# UNITED STATES PATENT AND TRADEMARK OFFICE

APPLICATION NO.	FILING DATE	FIRST NAMED INVENTOR	ATTORNEY DOCKET NO.	CONFIRMATION NO.
09.558,279	04.25.2000	Stephen Hollock	THOR-0002	8924

# Office Action Summary

Figure 1 - U.S. Patent 5,677,529 to Hofmann et al.

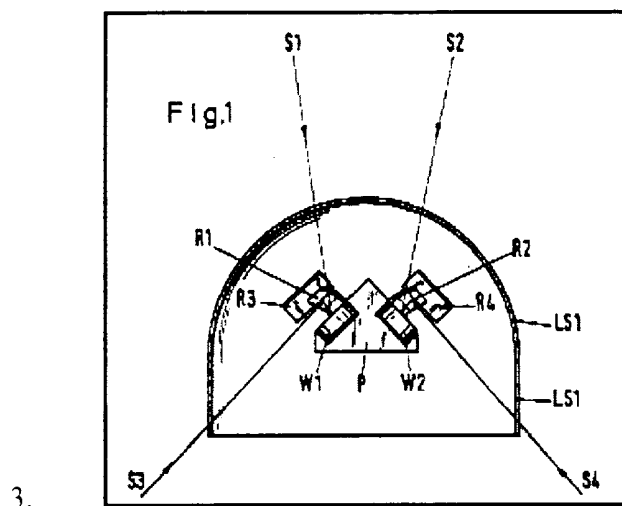
4. As per claim 1, Hofmann et al. disclose an apparatus comprising:

5. a) a detector (**W1**) and lens (**LS1**) to define a first field of view (**S1**) of the apparatus and to provide a single image of a distant scene on the array;

6. b) a reflector (**R1**, **R3**) arranged between the plane of the detector and the plane of the lens to define a second field of view (**S3**) which extends beyond the first field of view (**S1**) and to reflect onto the detector radiation entering the lens from outside the first field of view.

7. Hofmann et al. do not explicitly disclose an apparatus comprising a detector array.

8. It would have been obvious to modify the apparatus of Hofmann et al. such that it incorporated a detector array. One would have been motivated to make such a modification, based on a common sense understanding of radiation sensing, that a detector possessing a plurality of sensing elements (detector array) is able to provide high-resolution detail of a scene of interest.

18. As per claim 17, Hofmann et al. do not explicitly disclose an apparatus in which the further reflector is located outside the window. Hofmann et al. teach, however, the use of reflectors and lenses for shaping incidental radiation and directing it to a receiving detector array (see Fig. 1). The use (and arrangement) of bulk optical elements are well known means used to direct light and would be recognizable to one having ordinary skill in the art as means for beam shaping, focusing and/or propagation. It would have been obvious to one having ordinary skill in the art to modify Hofmann et al., incorporating the aforementioned limitations. One would have been motivated to make such a modification in view of the art-recognized practice of utilizing optical elements (and arrangement) for beam shaping, focusing and propagation.
